UNITED STATES PATENT AND TRADEMARK OFFICE

10/599,425

Office Action Summary	Application No. 10/599,425	Applicant(s) TANAKA ET AL.	
	Examiner MARTIN MUSHAMBO	Art Unit 2625

DETAILED ACTION

[Drawing 2]

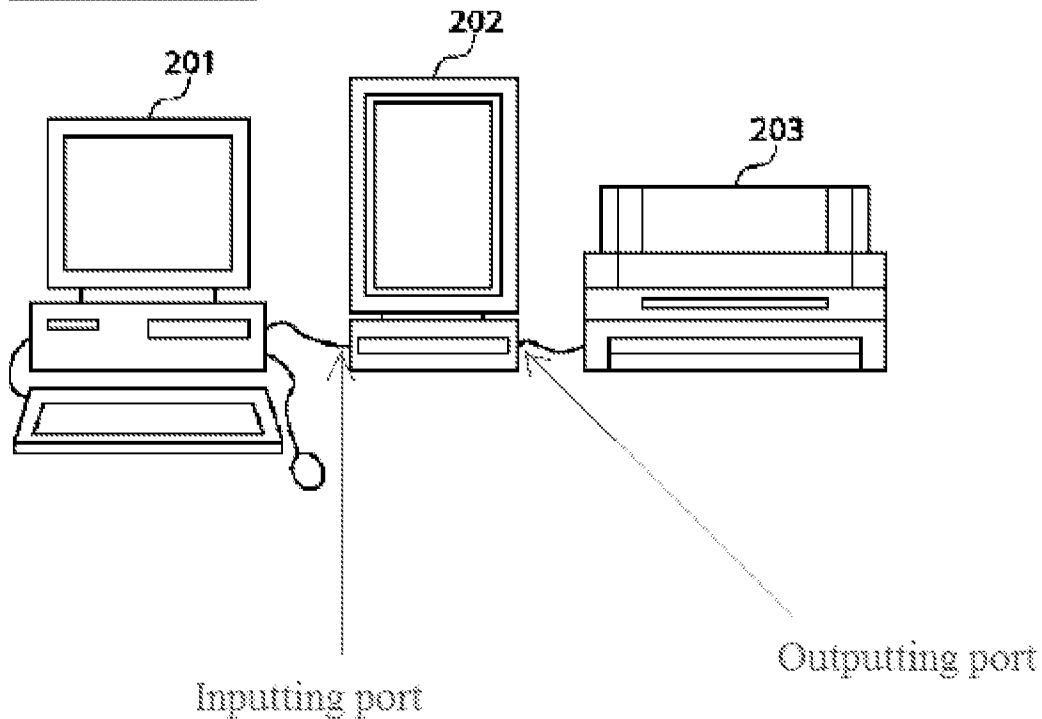
Regarding claim 19 dependent on claim 16, Mori as modified with Wabuchi discloses the print buffer unit, further comprising a data inputting port and a data outputting port. **(Mori, fig.2, see illustration below)**

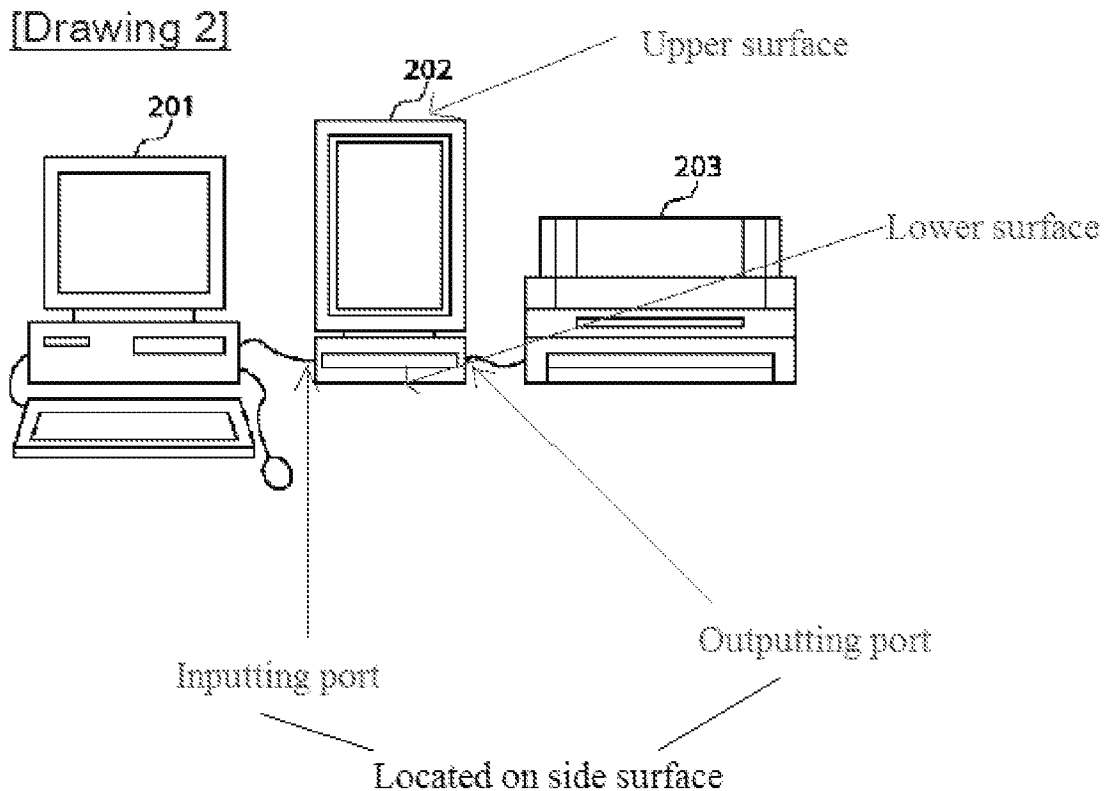
Regarding claim 20 dependent on claim 16, Mori as modified with Wabuchi discloses the print buffer unit, further comprising a housing having an upper surface, a lower surface opposite to the upper surface, and a side surface between the upper surface and the lower surface; wherein the data inputting port and the data outputting port are located at the side surface; **(MORI, fig.2 element 202, see illustration below)**

Mori and Wabuchi do not disclose “wherein the display panel is between the modification pad the data inputting port.” However, applicant has not disclosed any specific advantage or criticality of having the display panel between the modification pad and the data inputting port.. As such, the above limitations are a matter of design choice.
